ORIGINATION FORM

Proposed Revisions to a Standard Plans Index
(Please provide all information — Incomplete forms will be returned)

Index Number: 455-118

Index Title: 18" CFRP & SS Prestressed Concrete Piles

NOTES:

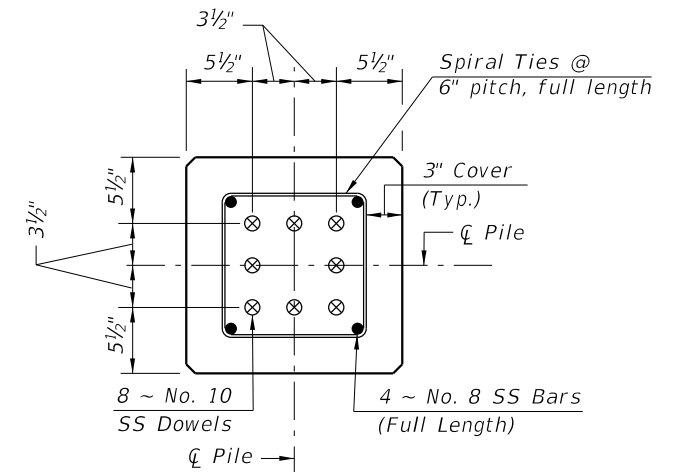
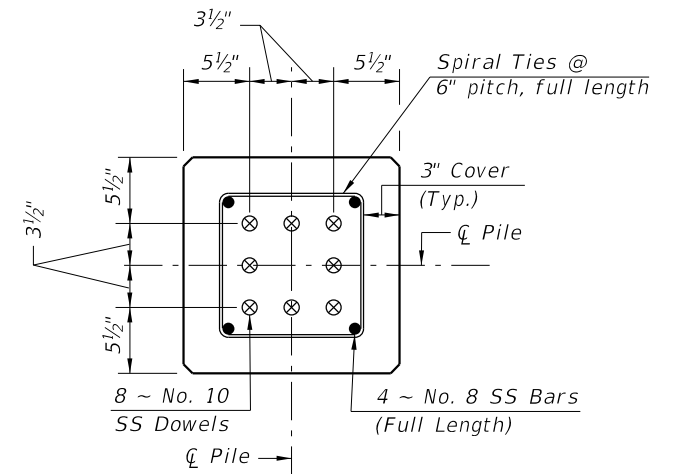
Added 0.6" HSSS strand

16 ~ 1/2" Ø, HSSS, at 26 kips
12~ 0.6" Ø, HSSS at 35 kips

16 ~ 1/2" Ø, HSSS, at 26 kips
12 ~ 0.6" Ø, HSSS, at 35 kips
